4/23/03	Revised 6'x4' Culvert Extension Per Change Order
DATE	REVISION
STATE OF HAWAII DEPARTMENT OF TRANSPORTATION HIGHWAYS DIVISION DRAINAGE PLAN - 1 KAMEHAMEHA HIGHWAY RESURFACING Waiahole Valley Road to Crouching Lion Inn Federal Aid Project No. NH-083-1(43)	
Scale: 1" = 10'	Date: August 1, 2000
SHEET No. C-27 OF 65 SHEETS

KAMEHAMEHA HIGHWAY RESURFACING
Waiahole Valley Road to Crouching Lion Inn
Federal Aid Project No. NH-083-1(43)

FED. ROAD DIST. NO.	STATE	FED. AID PROJ. NO.	FISCAL YEAR	SHEET NO.	TOTAL SHEETS
HAWAII	HAW.	NH-083-1(43)	2001	C.O.34S-1	121

SECTION A

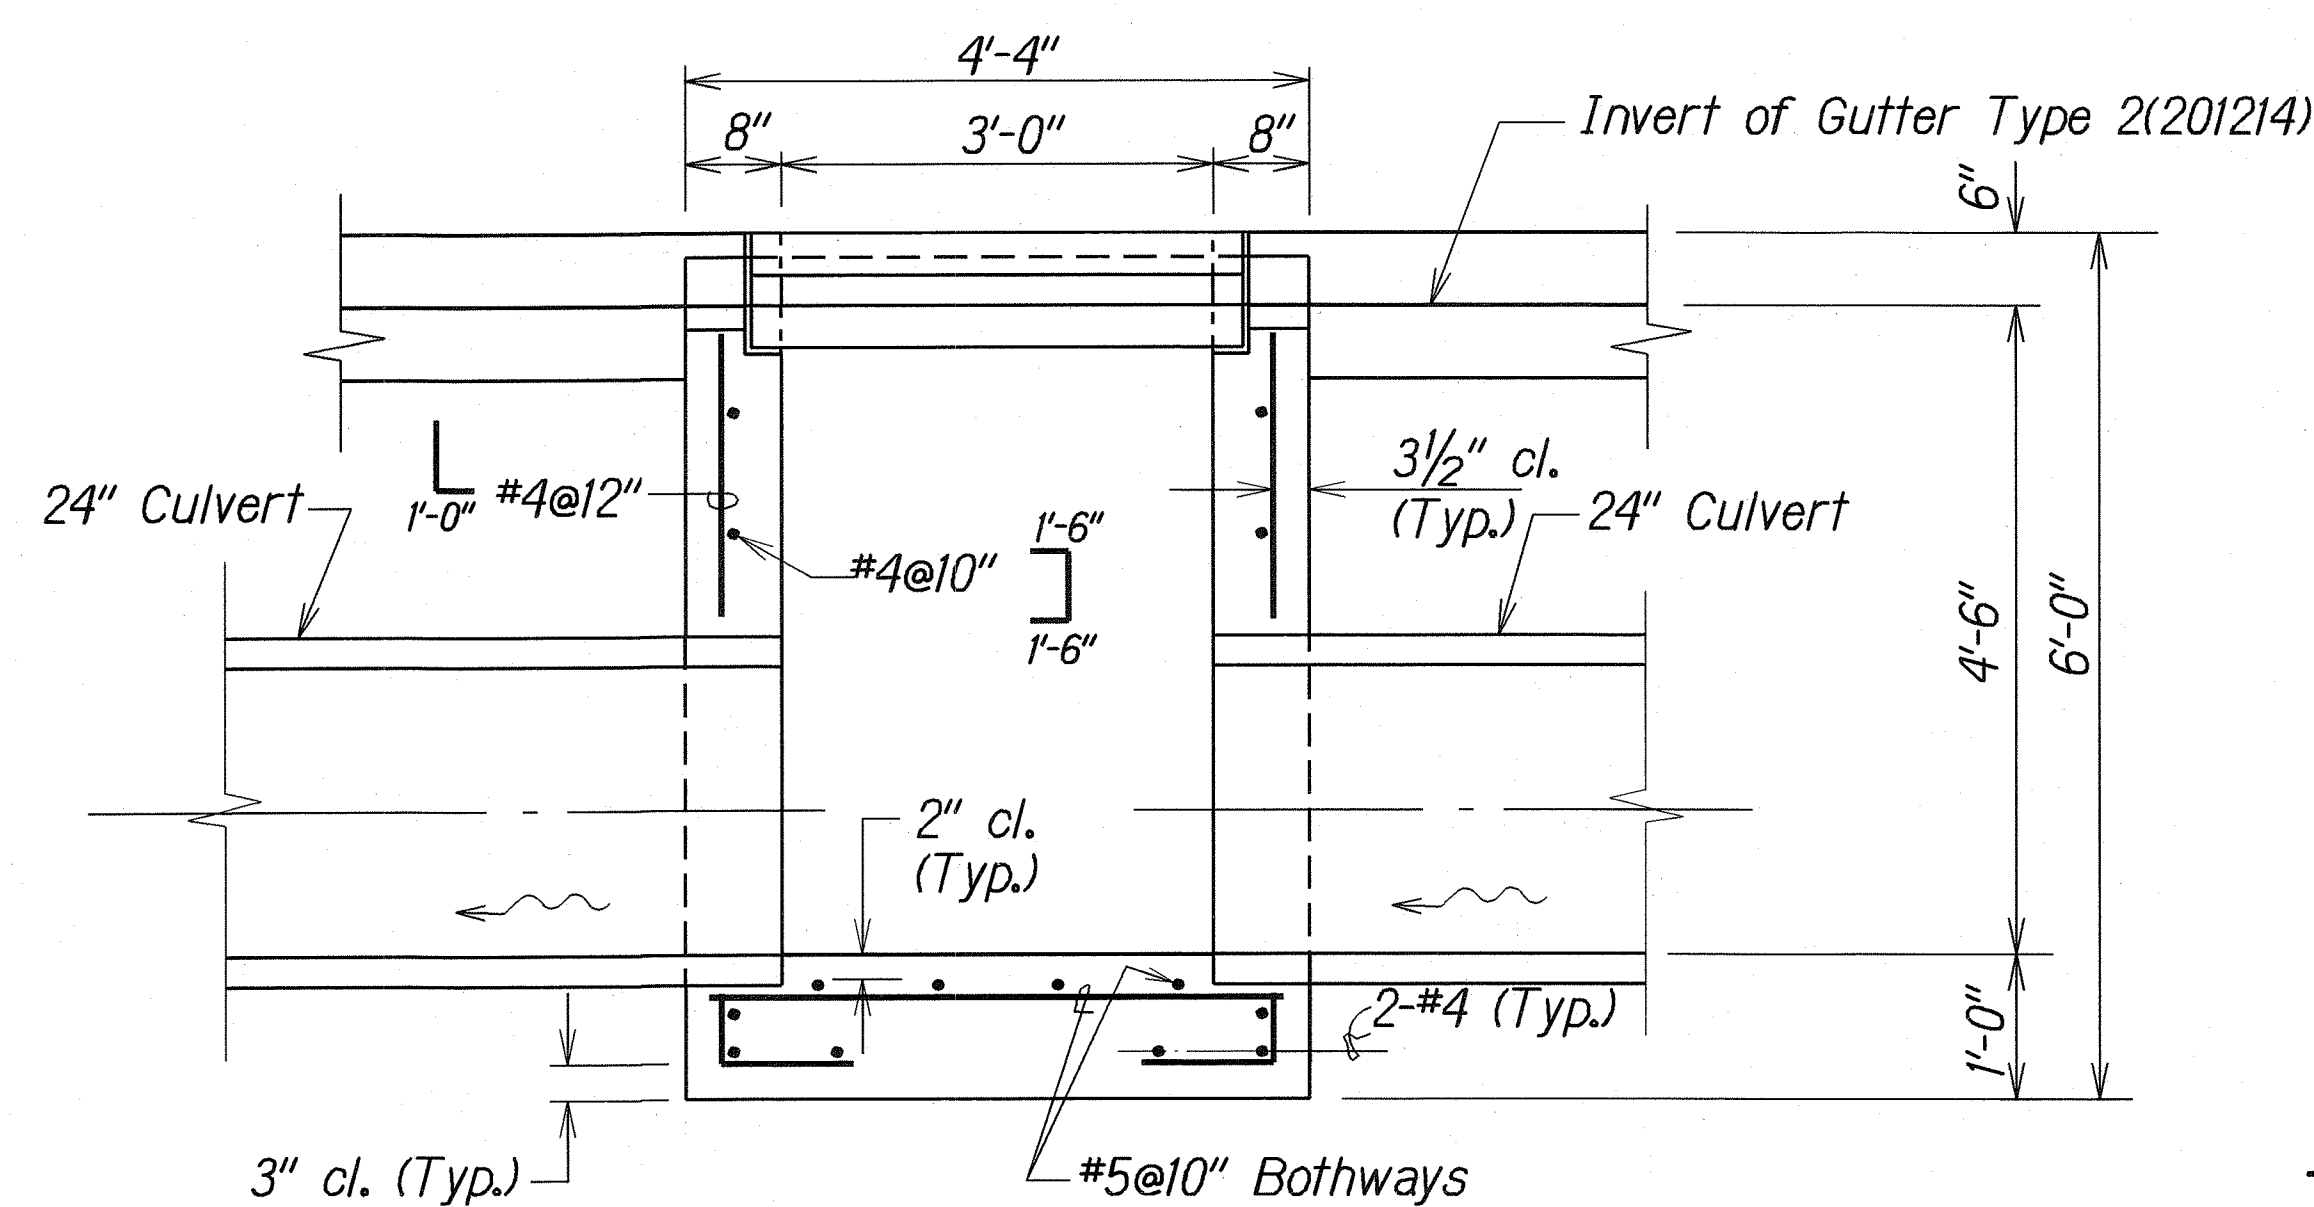
9/3/02	Add drainage detail of Type 201214P Grated Drop Inlet.
DATE	REVISION
STATE OF HAWAII DEPARTMENT OF TRANSPORTATION HIGHWAYS DIVISION DRAINAGE DETAILS KAMEHAMEHA HIGHWAY RESURFACING Waiahole Valley Road to Crouching Lion Inn Project No. NH-083-1(43) Scale: 3/4" = 1'-0" Date: Apr, 2002 SHEET No. C-32D OF 74 SHEETS

TYPICAL DETAIL OF CULVERT TRENCH AND GUTTER TYPE 2(201214)

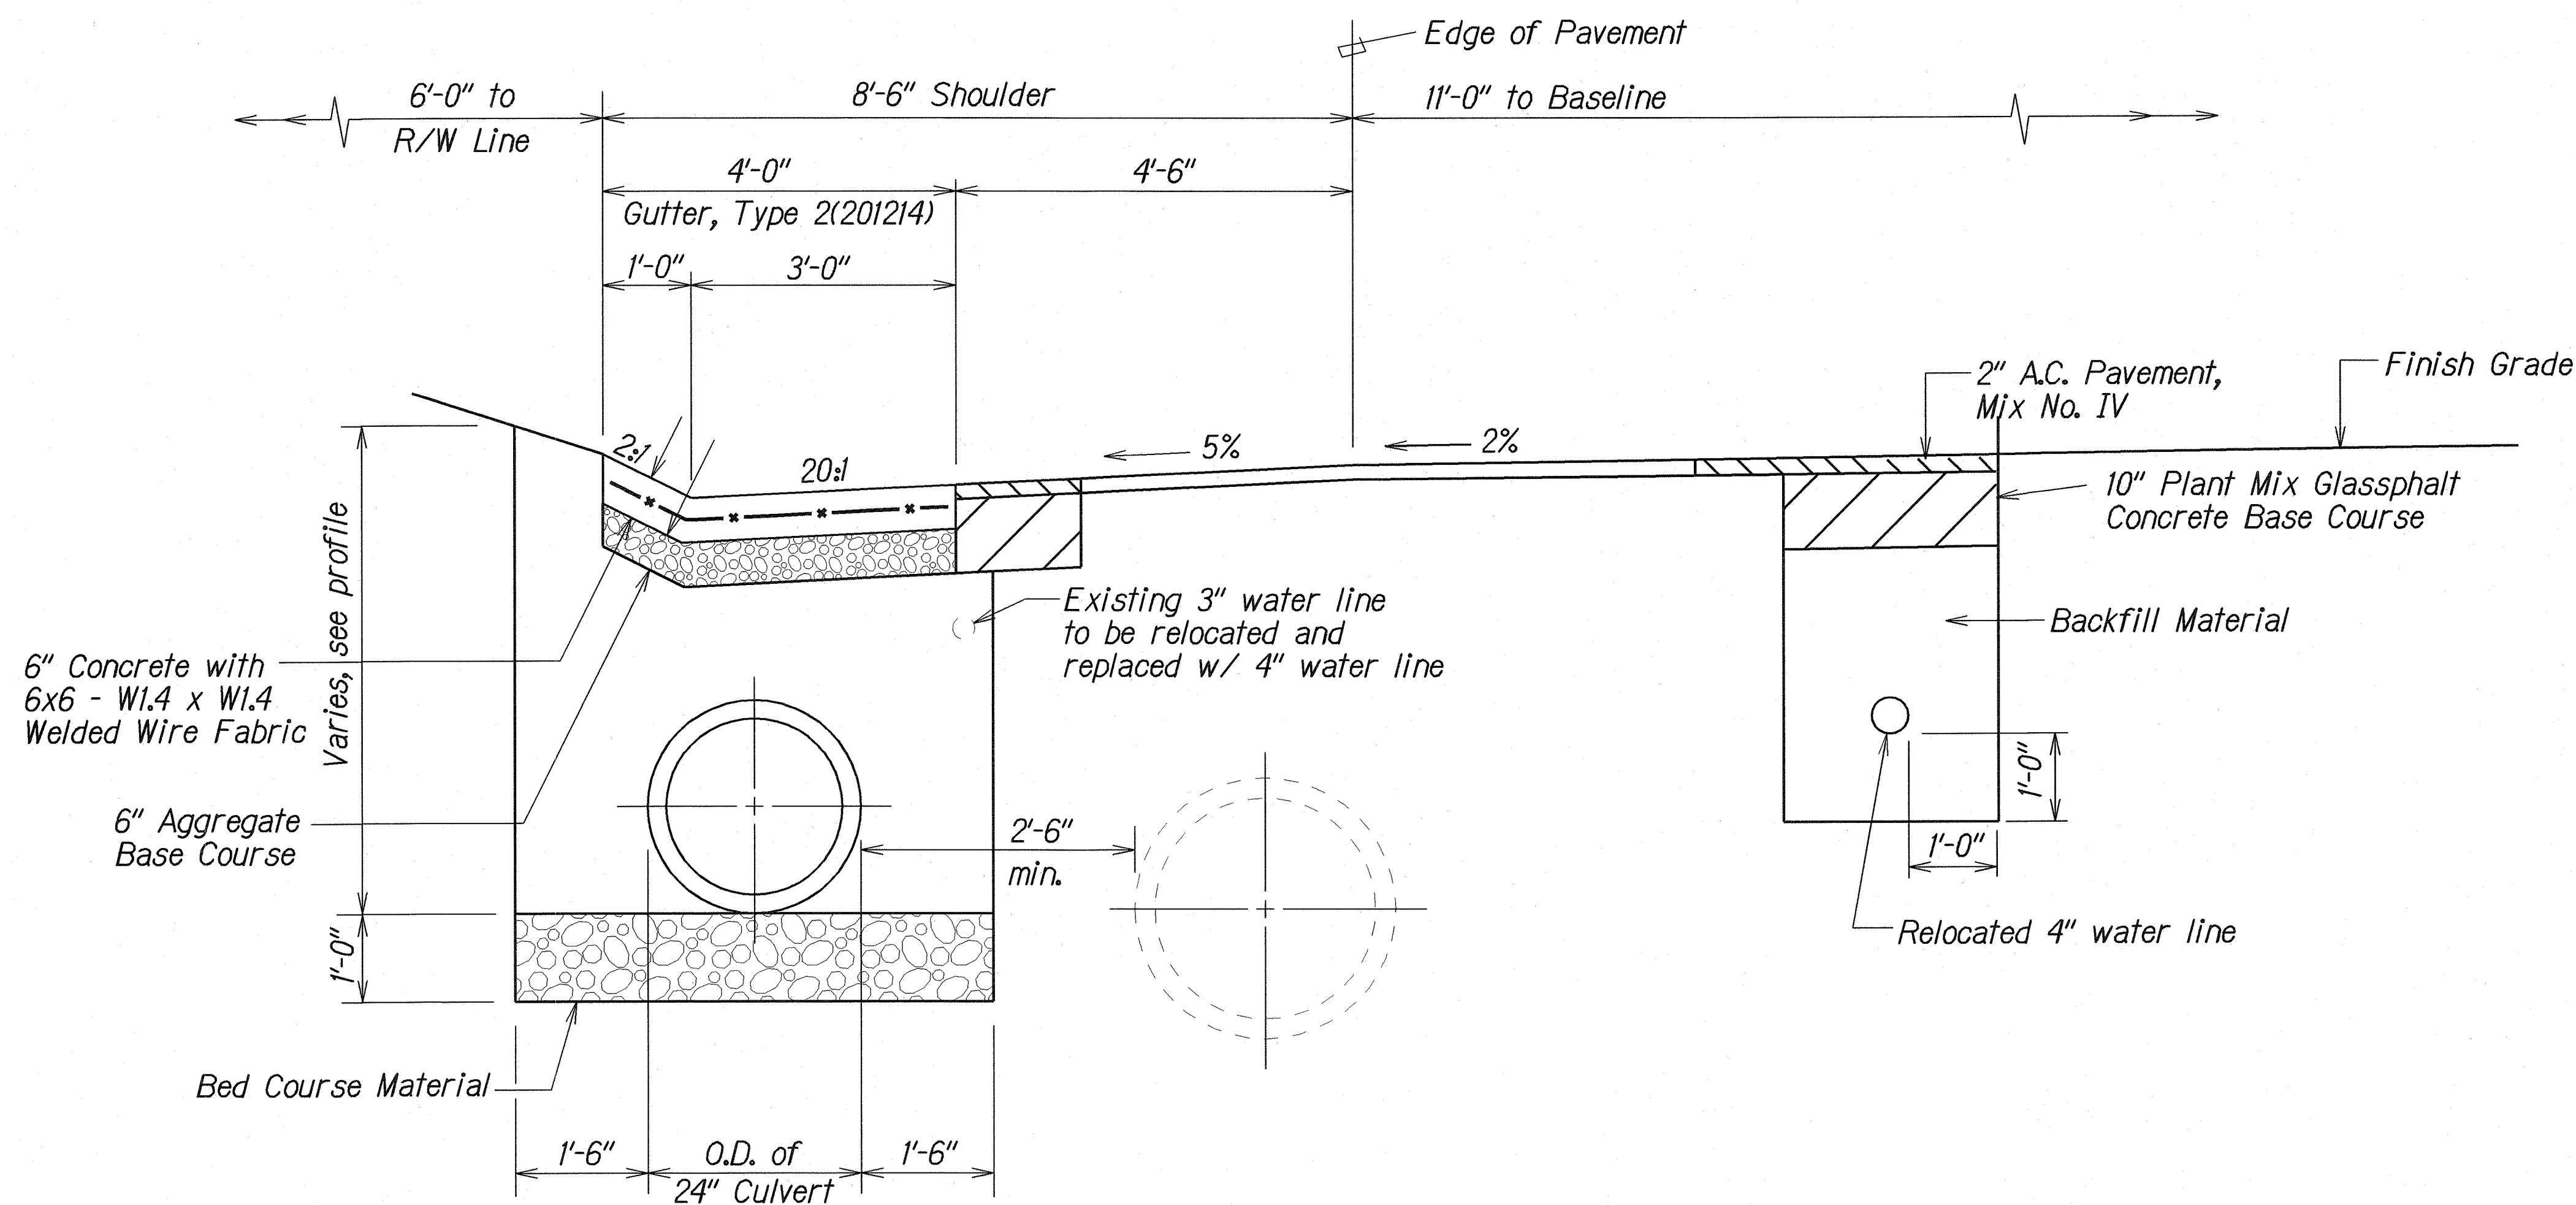
9/3/02	Add drainage detail of gutter and trench restoration.
DATE	REVISION
STATE OF HAWAII DEPARTMENT OF TRANSPORTATION HIGHWAYS DIVISION DRAINAGE DETAILS KAMEHAMEHA HIGHWAY RESURFACING Waiahole Valley Road to Crouching Lion Inn Federal Aid Project No. NH-083-1(43) Scale: 3/4" = 1'-0" Date: Apr, 2002 SHEET No.C-32E OF 74 SHEETS
